# TX SNDR and $R_{\text{peak}}$ limits for CR and C2M

Alexander Rysin and Piers Dawe, NVIDIA

Preset 1

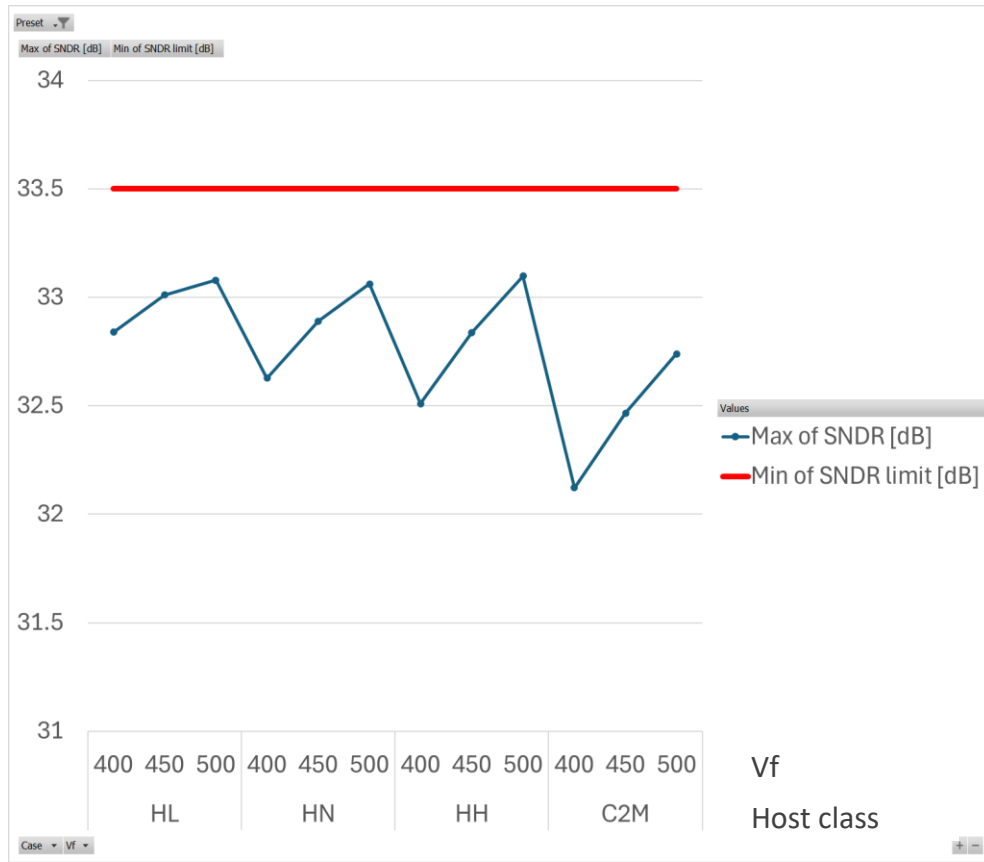
# SNDR Measurements

Preset	Current limit [dB]	Proposed limit [dB]
1	33.5	32
2	27.5	28
3	30.7	29.5
4	30.2	27
5	28.7	25.7
6 (initialize)	31	30

Preset 3

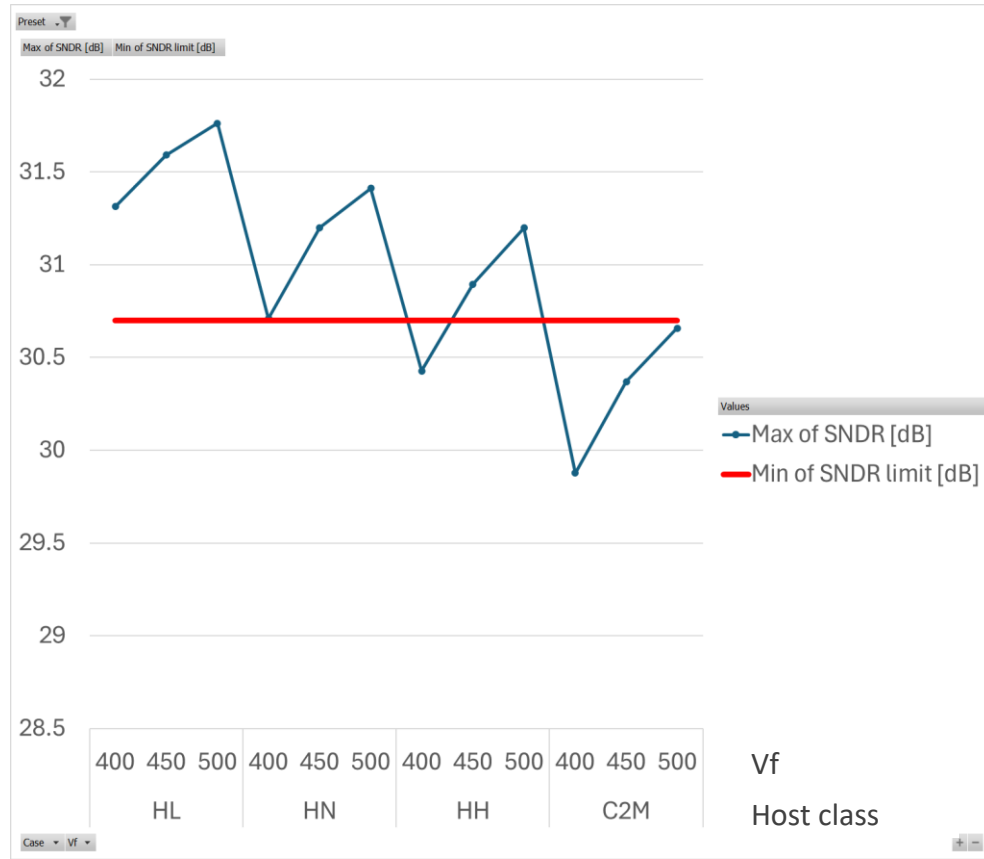
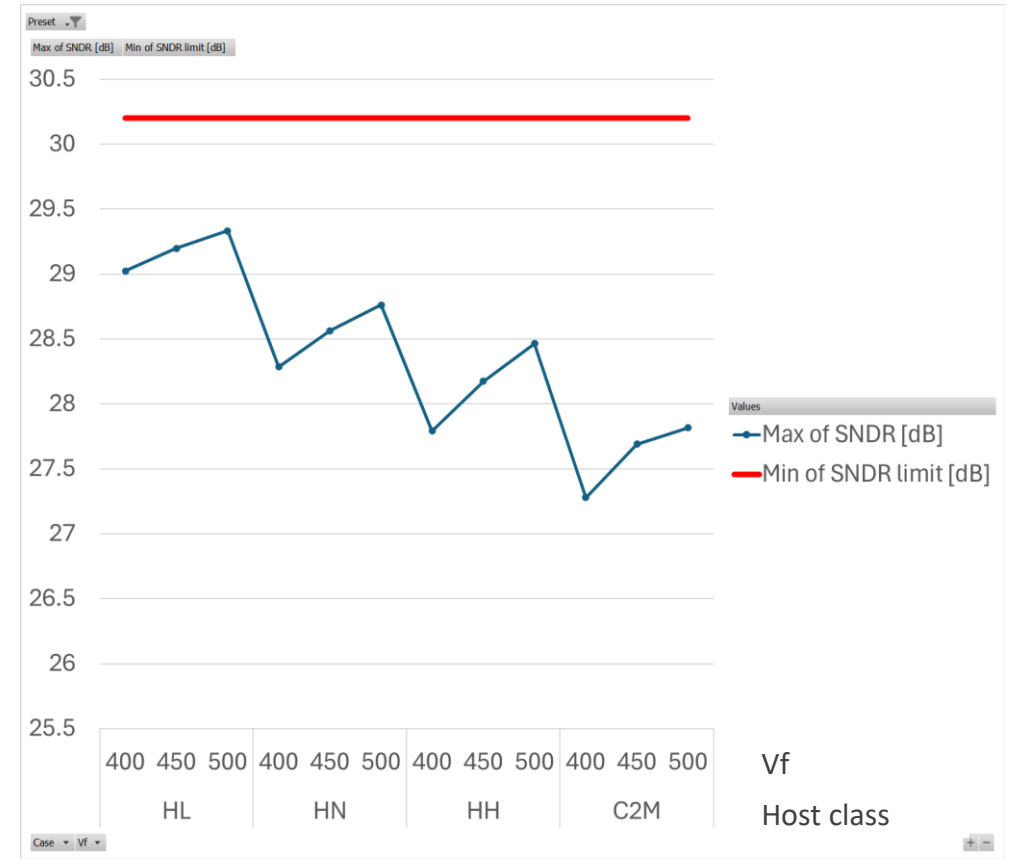
# SNDR Measurements

# SNDR Measurements

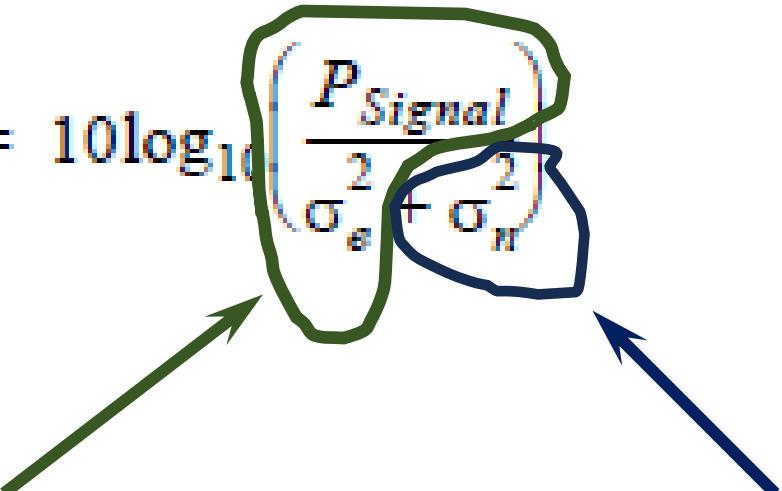
Scale with  $V_f$  and  
channel loss

Less dependent on  
 $V_f$  and channel loss

- Alternatively, define SNDR limits per host class, with values derived from lab data and reflecting measured dependence on loss and signal swing.
